STAFF REPORT

HEARING DATE: July 18, 2023
 DATE: Continued from: 6/27/2023
 TO: Mayor & City Council
 FROM: Sonya Allen, Associate Planner
 208-884-5533
 SUBJECT: Linder Village
[H-2023-0005](#)
 LOCATION: Southeast corner of N. Linder Rd. and W. Chinden Blvd., in the NW 1/4 of Section 25, T.4N., R.1W.

Modification to the existing Development Agreement (Inst. #2019-028376 & #2021-102392) to update the conceptual development and use area plans to amend some of the building footprints, vehicular/pedestrian site circulation and parking; and include multi-family residential as a future use.

G. Proposed Conceptual Development Plan (dated: 3/29/23)

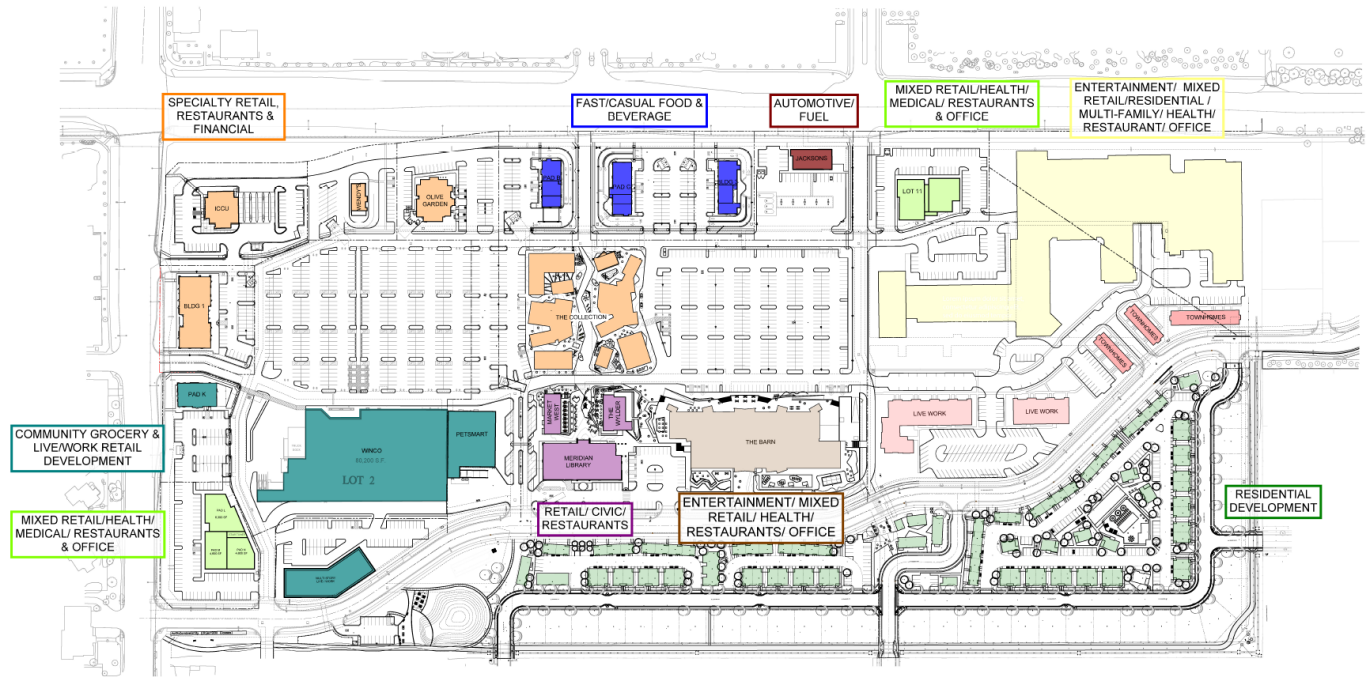
- Lots 1 and 2, Block 1, Linder Village West: Four (4) building pads were previously proposed for retail use. Four (4) building pads are still proposed – one (1) for retail use and three (3) for mixed retail/health/medical/restaurant & office uses – but in a different configuration with

Staff is amenable to this change as the pad sizes are substantially the same as the previous plan and the variety of uses is desired in the MU-C FLUM designation.

- Lot 16, Block 1, Linder Village: Two (2) multi-story live/work buildings were previously proposed – now, one (1) larger multi-story live/work building is proposed.

Staff is amenable to this change as the use is the same and the size is substantially the same. (Note: A live/work residential project is subject to the specific use standards listed in UDC [11-4-3-50](#) and is different from a vertically integrated residential project, which is subject to the specific use standards listed in UDC [11-4-3-41](#). The previous version of the UDC did not differentiate between the two uses when the previous conceptual development plan was approved.)

- Lot 1, Block 1, Linder Village South: This lot was planned to develop with a mix of specialty retail and restaurant uses in four (4) centralized 2-story buildings with a north/south drive aisle through the center with diagonal parking – now, eight (8) single-story buildings are proposed (i.e. The Collection) for specialty retail and restaurant uses with a pedestrian walkway and plaza for safe pedestrian circulation where the drive aisle and parking was previously planned. Conceptual elevations were submitted for the proposed structures, included in Section VII.M.

*Staff is amenable to this change as the use is the same; replacing the driveway and parking with a pedestrian walkway/plaza area is preferable to the previous design. **Staff recommends the east/west driveway between The Collection and the Market West and The Wylder buildings is restricted to emergency access only with collapsible bollards for pedestrian safety; the plans should be updated to reflect this change prior to City Council approval of the Findings.***

- Lot 4, Block 1, Linder Village South: Three (3) attached mid-anchor buildings were planned on the southern portion of this lot for entertainment/soft good uses, and one (1) pad for mixed retail/health & medical was planned at the northeast corner – now, one (1) vertically integrated multi-level/multi-tenant structure is proposed (i.e. The Barn) for entertainment/mixed retail/health/restaurants/office uses and the pad has been removed.

*Staff is amenable to this change as it should provide for a variety of uses as desired in the MU-C FLUM designation and contributes to the pedestrian-oriented community/plaza area where The Collection and the library are located. Conceptual elevations were submitted for The Barn structure, included in Section VII.M. **The proposed plans depict 90-degree parking in front of the building requiring vehicles to back out into the main east/west drive aisle, which creates safety concerns with vehicles backing out into a main drive aisle. Therefore, Staff recommends the plans are revised to remove the parking in this area prior to City Council approval of the Findings.***

- Lots 12 & 13, Block 1, Linder Village: One (1) large office and a smaller office pad were planned along with five (5) retail building pads for future office/retail use – now, two (2) live/work buildings, three (3) multi-family (townhome-style) structures, and one very large mixed use/multi-family building is proposed for entertainment/mixed retail/residential/multi-family/health/restaurant/office uses. (Note: The footprint of the proposed multi-family building is preliminary and subject to change and future agency approval.)

*While the Comprehensive Plan does support higher density and/or multi-family residential development for projects with the potential to serve as employment destination centers and when the project is adjacent to US 20/26, Staff is concerned with the provision of an adequate mix of uses on Lots 12 & 13 so that the area isn't primarily multi-family and includes community-serving uses consistent with the purpose statement of the MU-C designation. Staff is also concerned with the height of the structure(s) being compatible with adjacent existing and future buildings in the general area. **Therefore, Staff recommends a new DA provision limiting the overall residential density on these two lots to a maximum of 15 units/acre based on the 13.66-acre area (which equates to a maximum of 205 units), consistent with the density desired in MU-C designated areas. Additionally, in accord with the MU-C guidelines, Staff recommends a DA provision that limits the building footprint of structures to 30,000 square feet unless a structure contains a mix of both residential and office, or residential and commercial land uses. Where the development proposes public and quasi-public uses to support the development above the minimum 5%, the developer may be eligible for additional residential densities and/or an increase to the maximum building footprint. Finally, Staff recommends the height of the structure(s) is limited to 3-stories in height for compatibility with adjacent existing and future structures in the area.***

#5.1p: “The overall residential gross density on Lots 12 and 13, Block 1, Linder Village Subdivision, shall be limited to a maximum of 15 units/acre based on the 13.66-acre area with a maximum building height of 3-stories. Where the development proposes public and quasi-public uses to support the development above the minimum 5%, the developer may be eligible for additional residential densities.”

#5.1q: “The building footprint of structures shall be limited to a maximum of 30,000 square feet unless a structure contains a mix of both residential and office, or residential and commercial land uses, in accord with the Mixed-Use Community future land use designation in the Comprehensive Plan. Where the development proposes public and quasi-public uses to support the development above the minimum 5%, the developer may be eligible for an increase to the maximum building footprint.”

I. Proposed Site Circulation Plan (dated: 3/29/23)

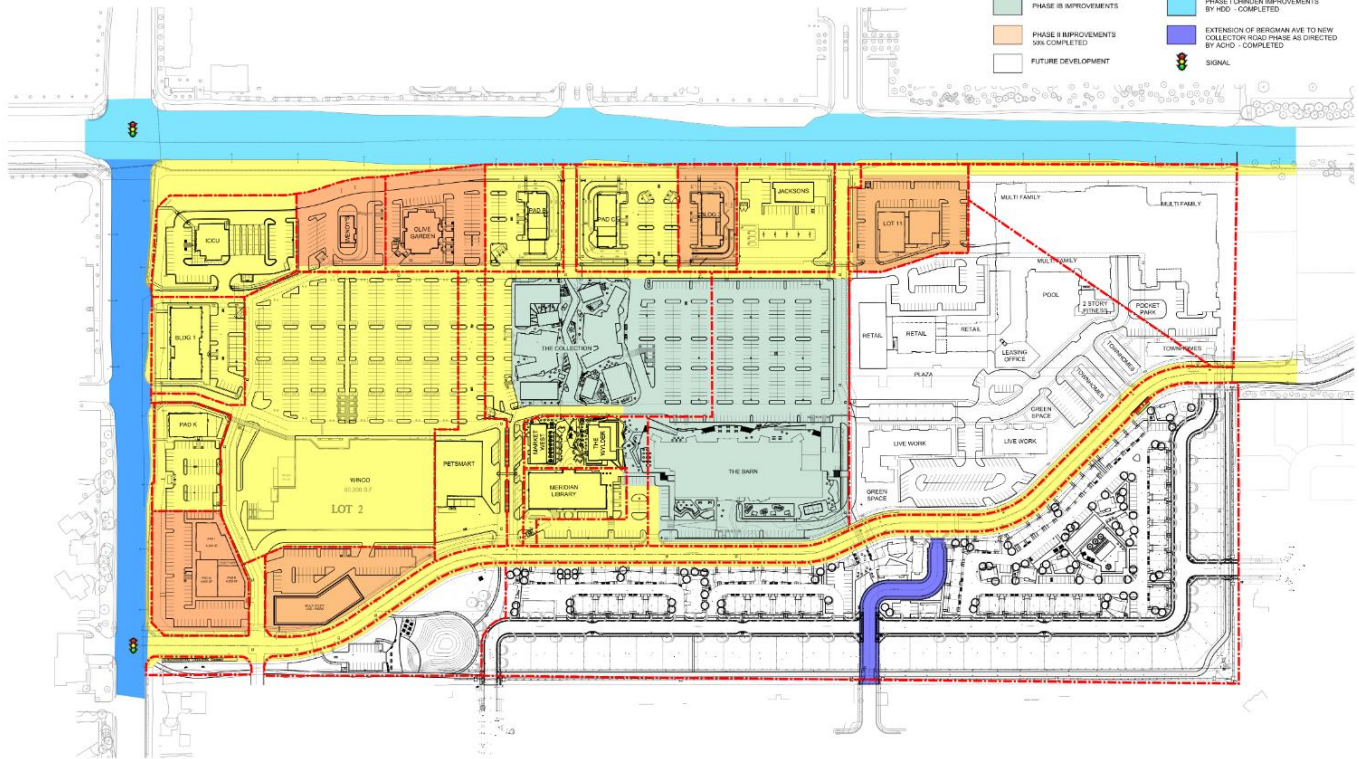
*An updated pedestrian circulation plan was submitted with this application, which should assist in ensuring safe pedestrian access and connectivity within this development. **Staff recommends the east/west driveway between The Collection and the library is restricted to emergency access only with collapsible bollards to enhance pedestrian safety in this area.***
